SKILLING, HELLE, CHRISTIANSEN, ROBERTSON — Structural & Civil Engineers

PROJECT THE WORLD TRADE CENTER | TITLE FLOOR TRUSS C 32T-5 - FEB. FIRE TRUSS REPAIR | DATE 2-24-75

TWO TRUSSES ON COL. LINE 233 (Looking South)

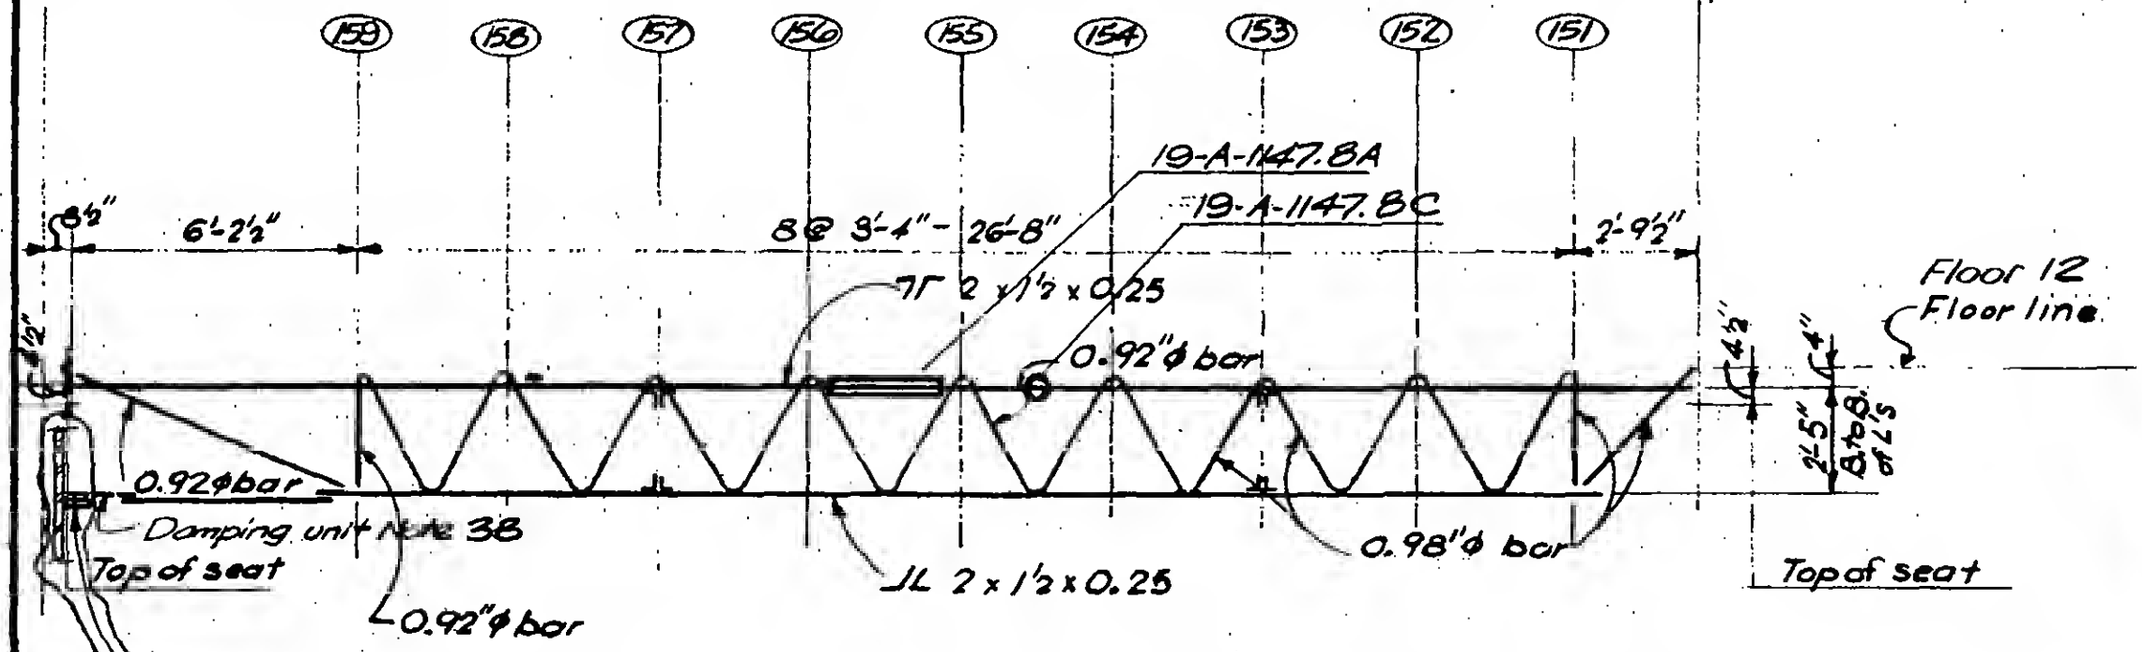
Heat and straighten Damper connection ℄ at spandrel.
Temperature not to exceed 1250°F.
